Amendments to the Drawings:

The attached sheet of drawing includes the following changes to Fig. 2.

DP-305008

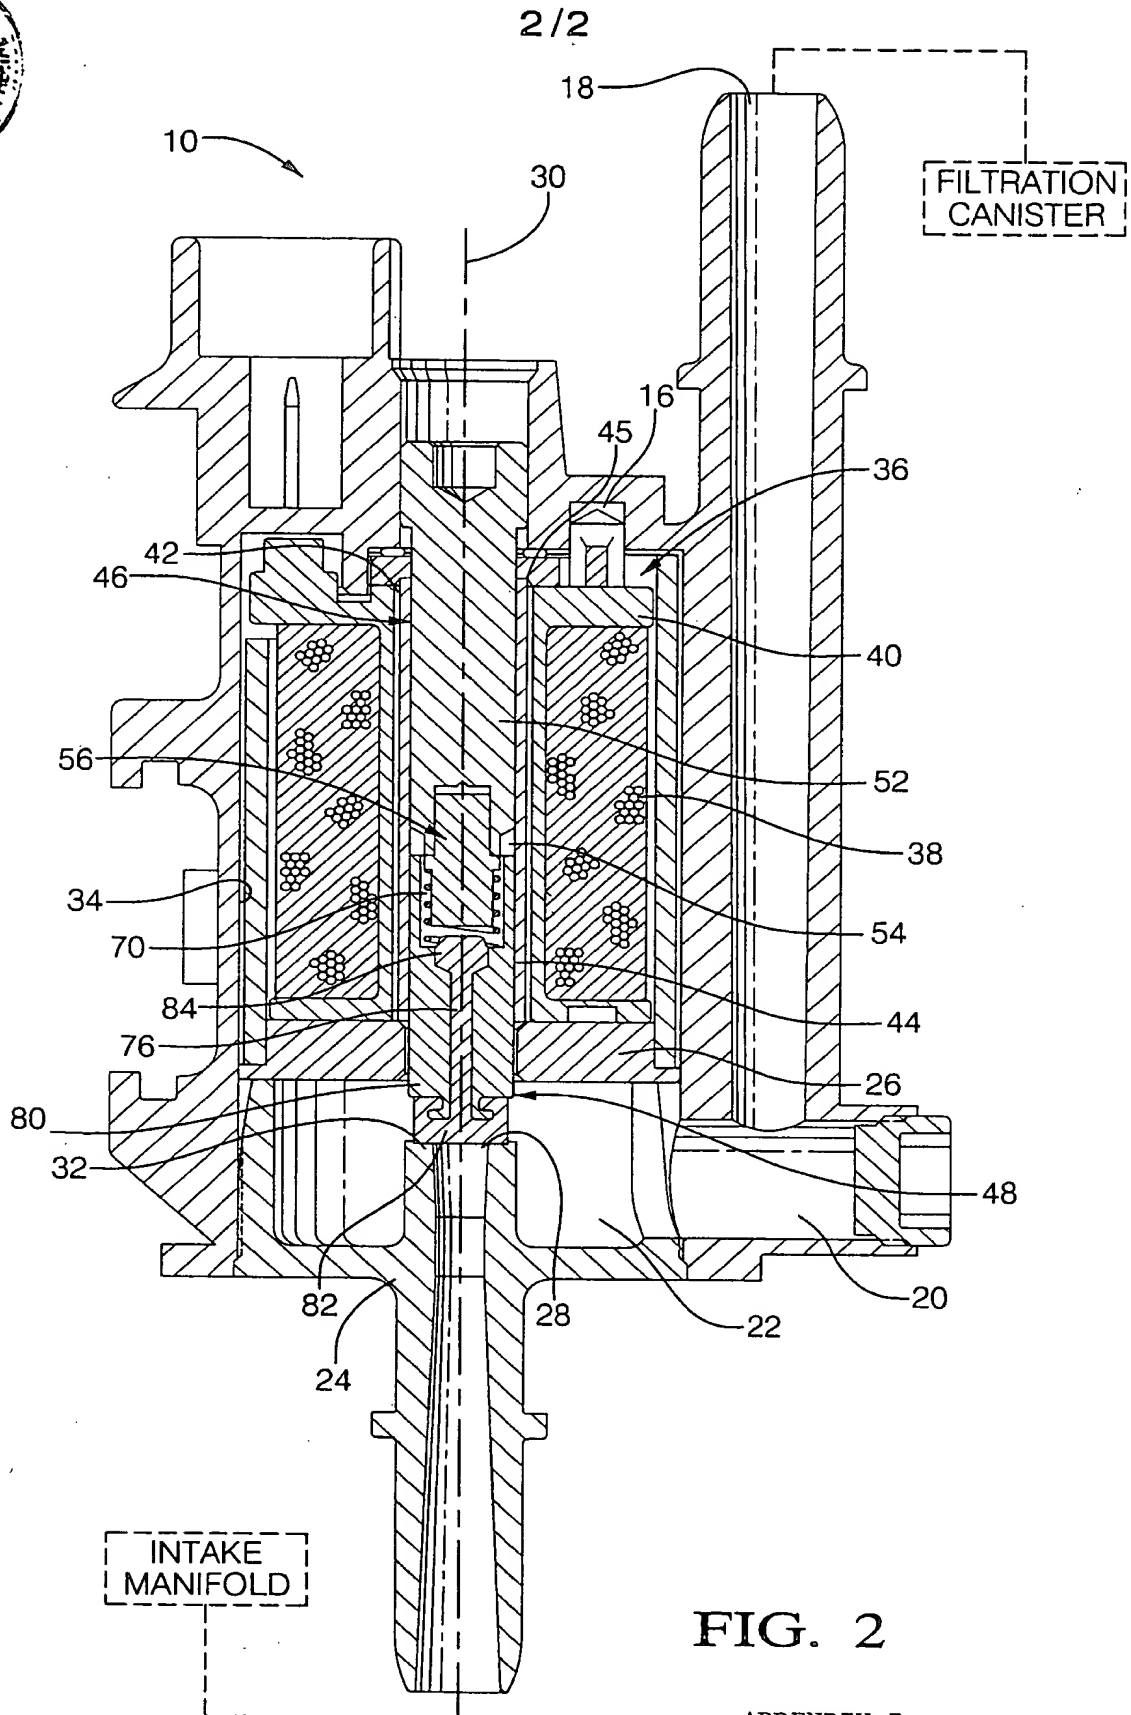
Add Reference No. 18 and leader line directed to the inlet. Further, other corrections have been made to correspond with Figure 3 and the Specification.

Reference No. 48 and leader line is redrawn to be directed towards the plunger. The original Reference No. 48 has now been changed to No. 56 for a non-conductive stop insert.

Reference No. 34 is listed twice in Figure 2. The uppermost Reference No. 34 has been corrected to be Reference No. 46 for the valve stop. The uppermost Reference No. 46 and leader line has been deleted.
